From: Mark A. Olinger <cincygrad@yahoo.com>
Sent: Monday, June 16, 2025 4:01 PM
To: Oliver, Alyson E. - PDR
Cc: Newbille, Cynthia I. - City Council; Patterson, Samuel - City Council Office; Alessandro Ragazzi
Subject: Rezoning of M & Glenwood Area from R-5 to R-63
Attachments: M & Glenwood Comments.pdf

Glenwood to M Rezoning Request

GLENWOOD to M ST
Richmond, VA

Proj: 2024018
Date: 2024-01-14
Rev: 01

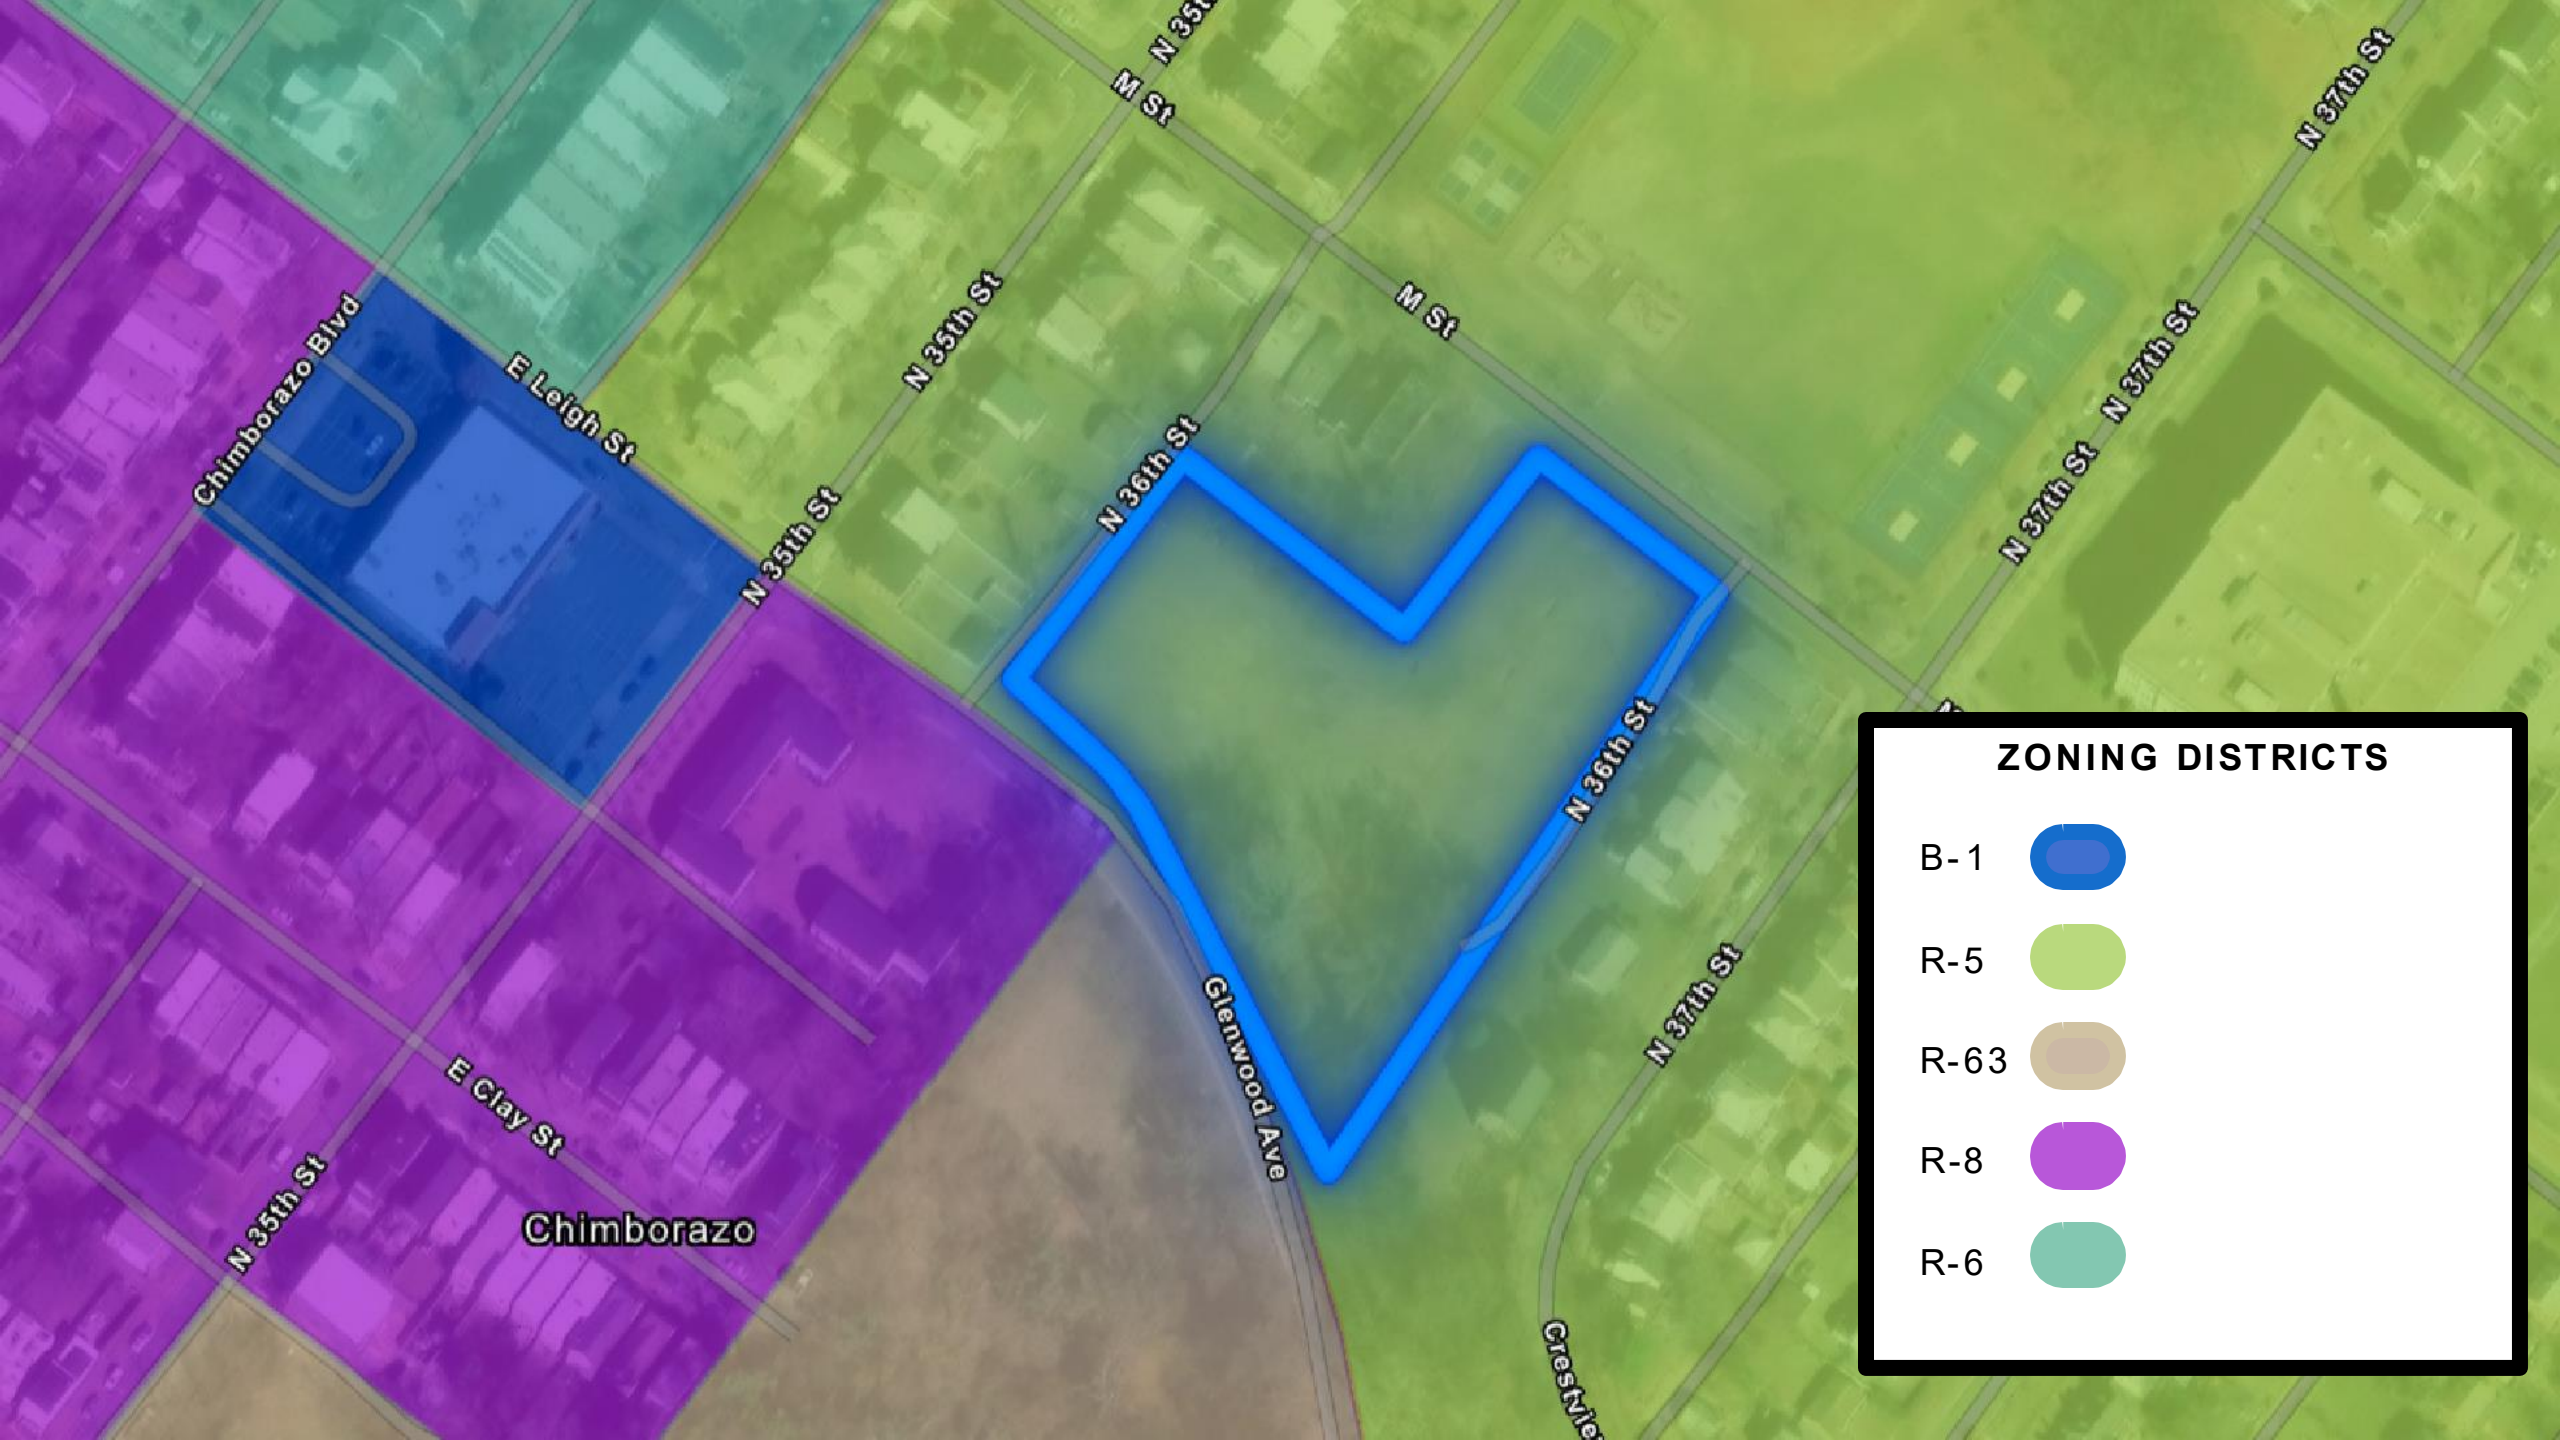
- The concept plan is not a plan; it's a lot lay-out. It could change significantly following rezoning. Don't have a clue about scale/lot sizes or unit mix..

- "Concept Plan" doesn't address topography and existing tree area fronting on Glenwood (R300, HQP, Objective 4.1.a—c., e., f., h., and i.) and how that may affect lots, access, alleys, etc. How is that to be addressed?

R/W Sidewalk Improvements

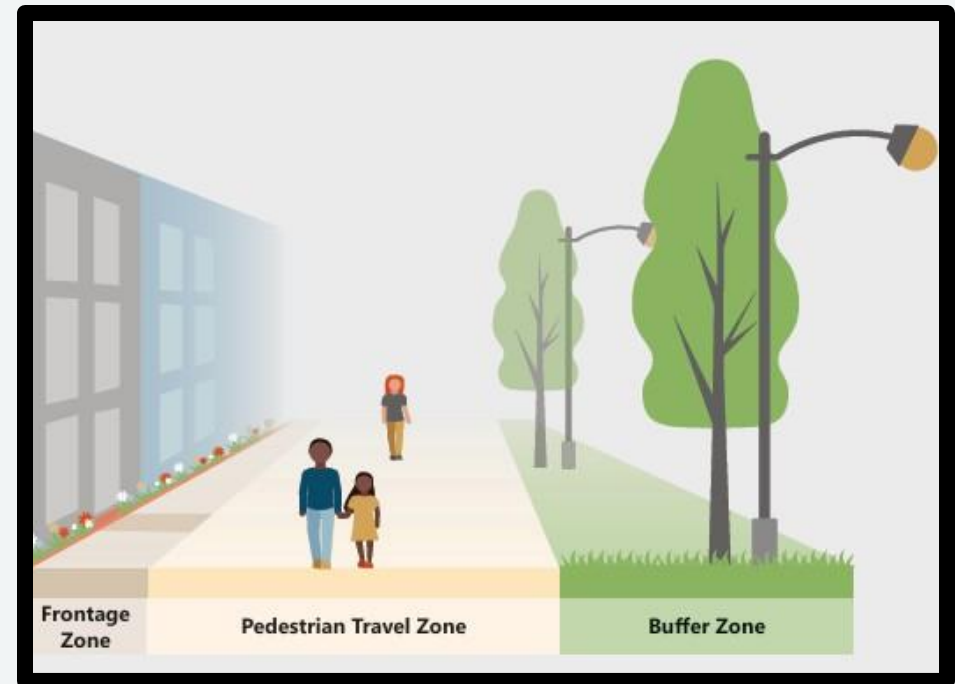
- Sidewalks are required on both sides of street per the Subdivision Ordinance so not sure how this rises to level of proffer. Sidewalks on M vary but are at least 6' wide along M St. frontage and use that as link to neighborhood.

- Request: Remove frontage zone and add the .5' (6") to the buffer zone for trees.
- I can't find any provision for street trees in the Subdivision Ordinance.

- Request: Amend proffer to have the development follow existing r/w frontage along M St. and Glenwood Ave. for sidewalk width and street tree locations (please see next slide) identified by Urban Forestry. With no overhead utilities, plant at minimum medium-sized trees within interior of site in addition to following Street Tree Inventory recommendations and where appropriate, large-size street trees.

- Request: Amend proffer to "Provide for minimum 1 off-street parking space" period, not "to extent practicable."
